# SERVICE BULLETIN

SB No. **L-410/005b**

Aeroplane Type: **L-410**

**Subject:** Inspection and possible replacement of the bracket in the power steering of the nose landing gear.

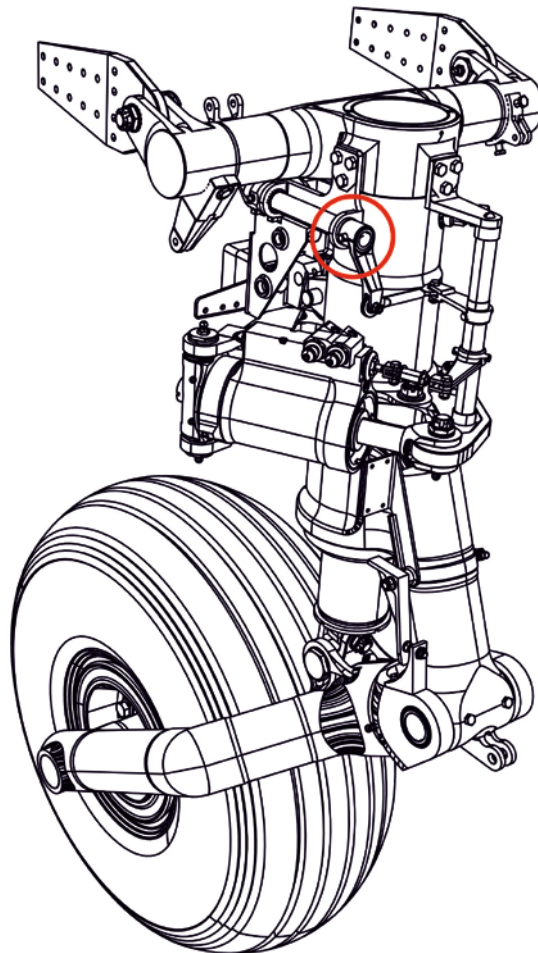
Using a 6x magnifying glass, check for cracks in the nose thruster power steering bracket type no. 3 245 092 0 (order no. 2 123 092) pos. 92 on the drawing of the nose landing gear in Annex 1, in the area as show in the figure below. Cracks on the bracket are not permitted.

If cracks are found on the bracket, replace the bracket according to section 2.B. of this bulletin.
